## DESCRIPTIVE REPORT

*Type of Survey*            FIELD EXAMINATION

*Registry No.*              F00542

*Locality*                  PRESQUE ISLE BAY

Figure 1.2.1

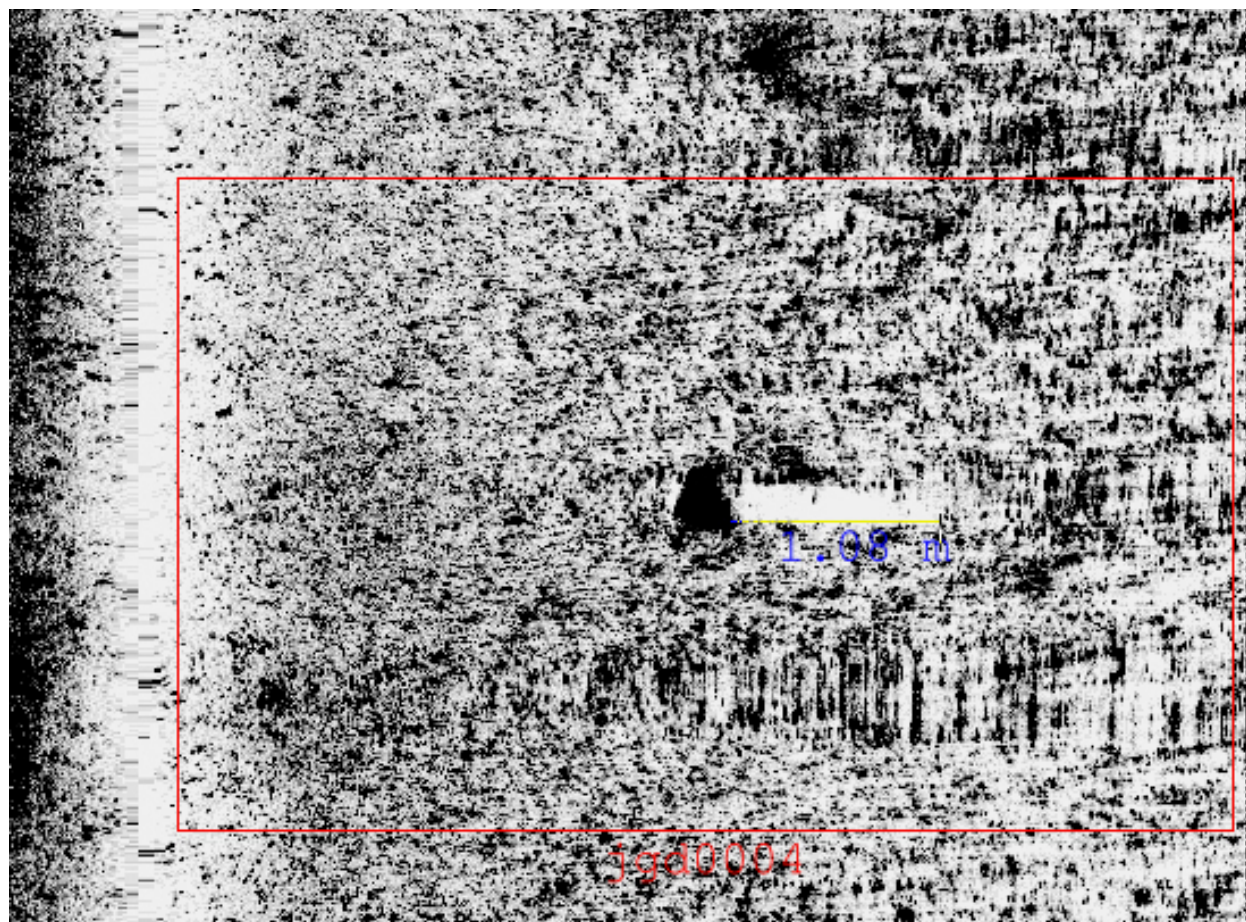
Rock 1.14m height in approximately 12ft depth. The rock is located approximately 117m with an approximate azimuth of 285° from the marina entrance. Rock was not originally thought to be navigationally significant. But, further review from AHB has determined this rock to be a Danger to Navigation. Rock was not investigated by field party at the time of survey so, no Least Depth was obtained.

Upon advice from AHB, hydrographer recommend charting submerged rock with depth reported.

Concur with clarification. Originally submitted as F00542's first DtoN submission, #1. Recommend to delete charted rock with depth unknown as submitted for DtoN #1. Recommend to chart feature as 7-ft Rock (rep 2007); estimated least depth of 7.74-ft (2.36m).

Figure 1.5.1

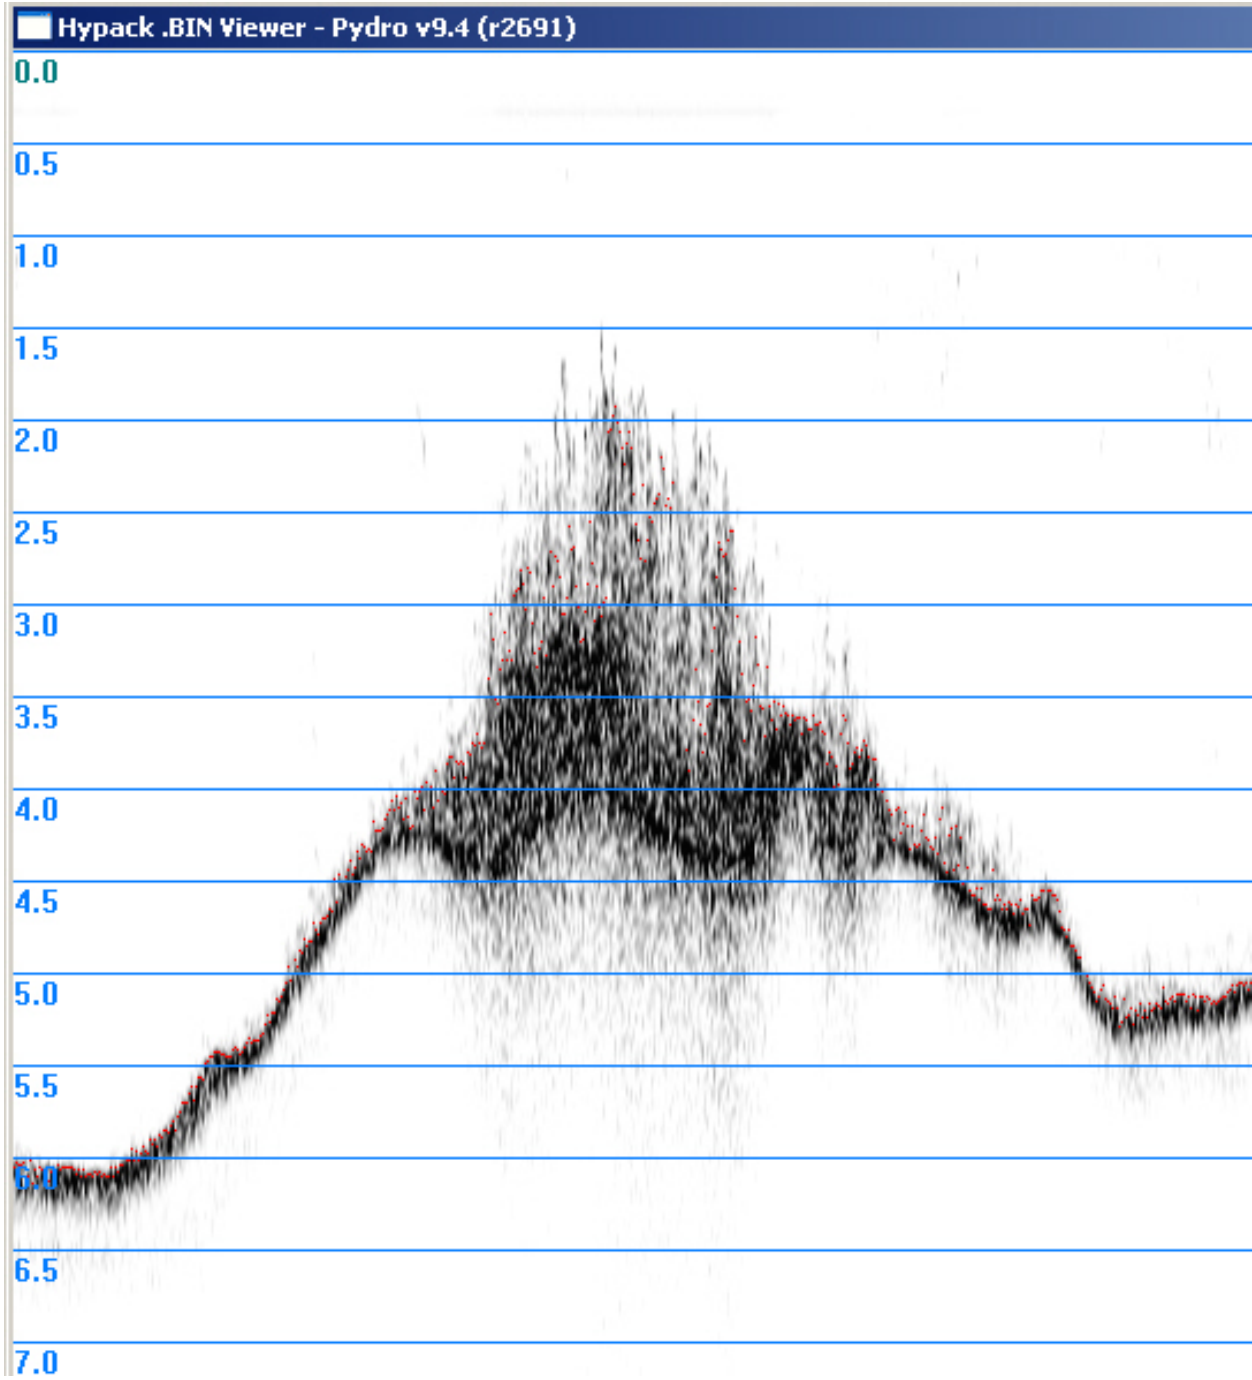
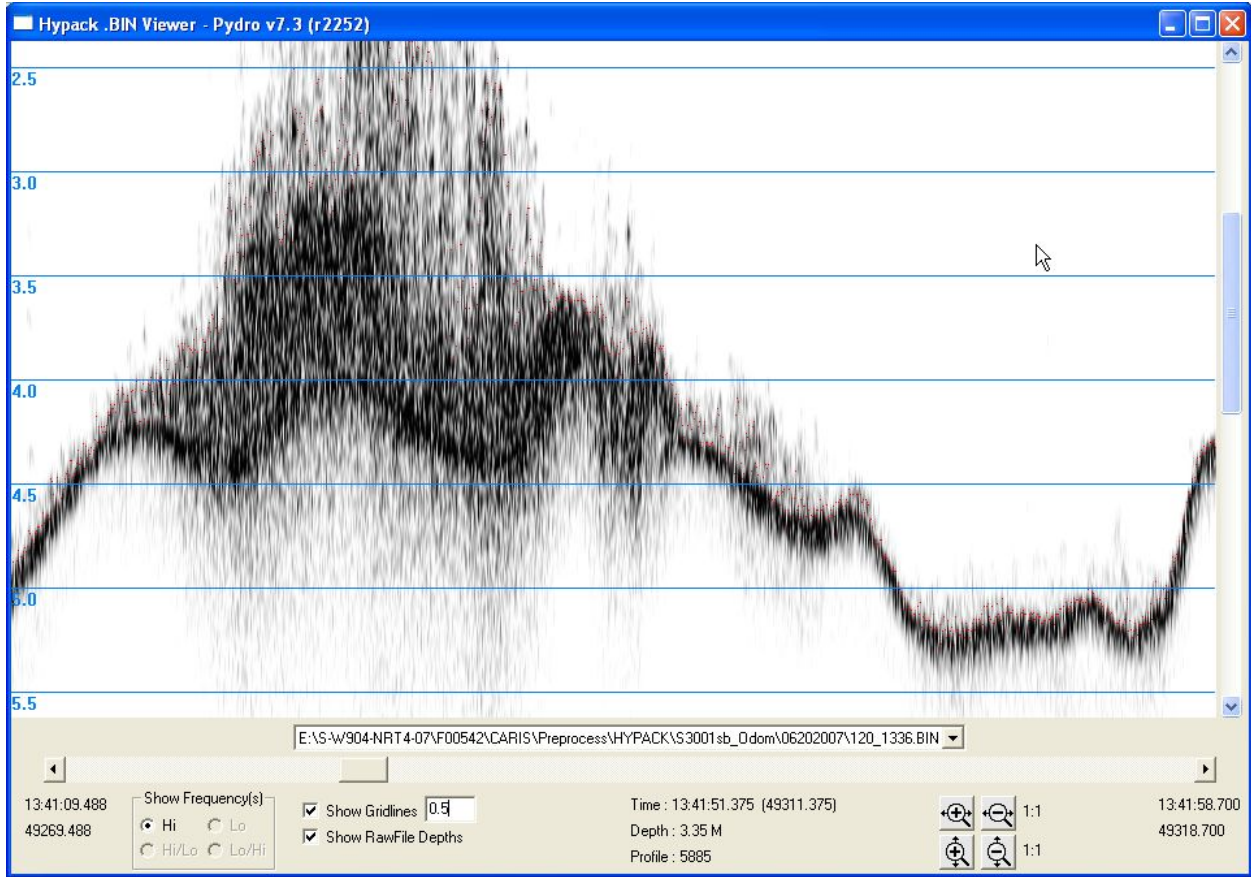
Seven foot sounding found in 11-12 foot charted depths.

Hydrographer recommends charting 7 ft sounding.

Originally submitted as F00542 second DtoN submission, Item 1.1. Do not concur. At the time of AHB compilation the 7-ft depth is not charted. No charting action is required.

Data verification indicates that the submitted DtoN shoal depth was echo sounder returns on grass. Data review of raw graphic records and data editing indicates the shoal depth within the immediate common area is 10-ft. Recommended to not to chart the 7-ft sounding located in 42°08'44.716"N, 080°06'14.1"W. Recommend updating the chart to reflect edited survey depths within the common area.

*Figure 1.8.1*

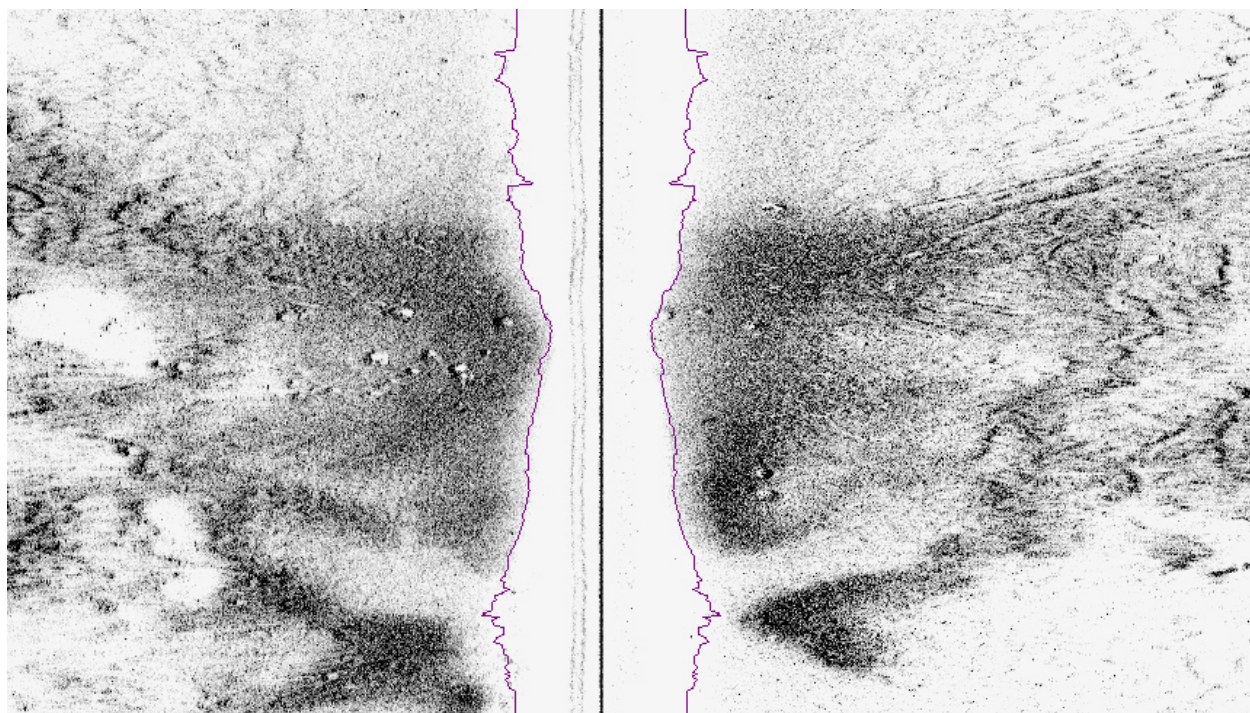
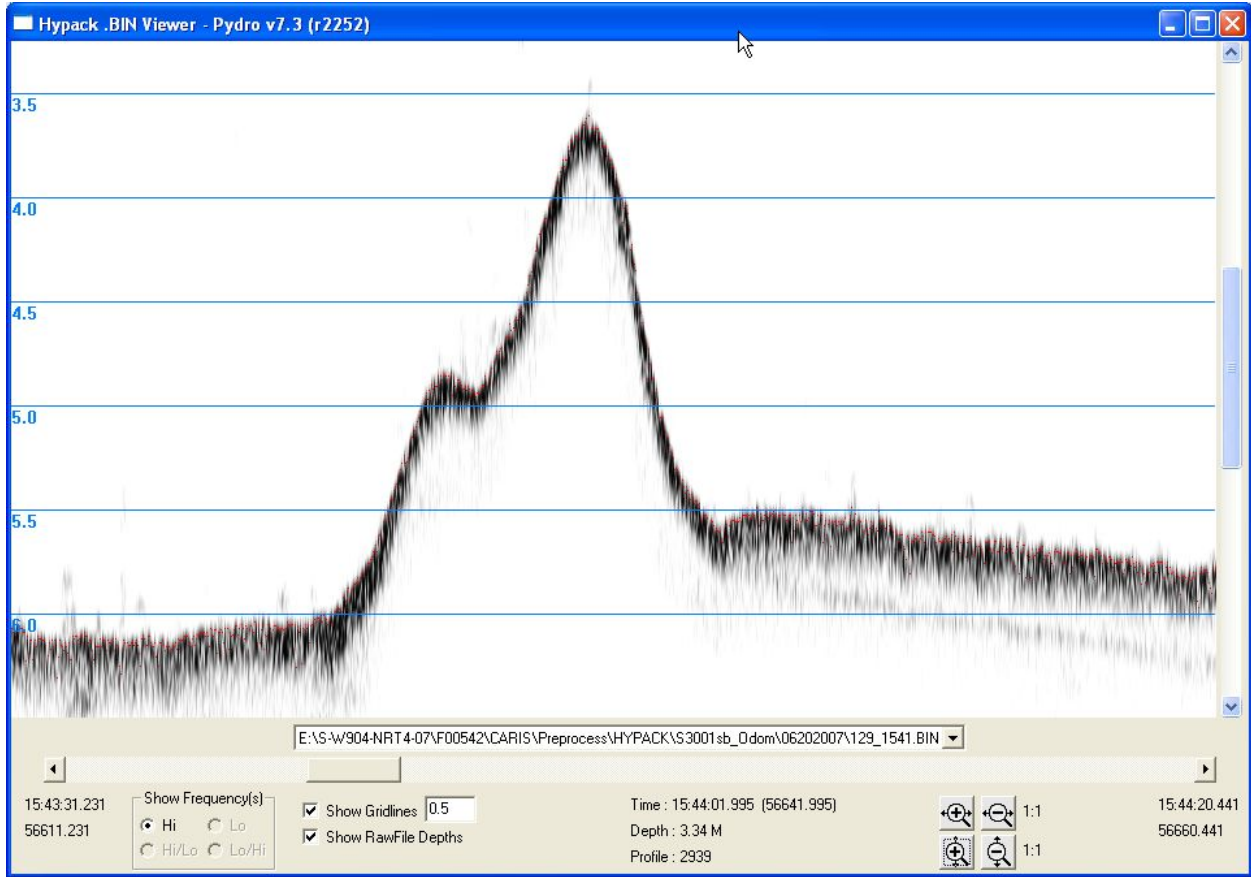
10 ft sounding found in 18 ft charted depth area.

Hydrographer recommends charting 10ft sounding.

Originally submitted as F00542's second DtoN submission, Item 1.2. AHB concurs w/ the field. Retain as charted, no cartographic action required.
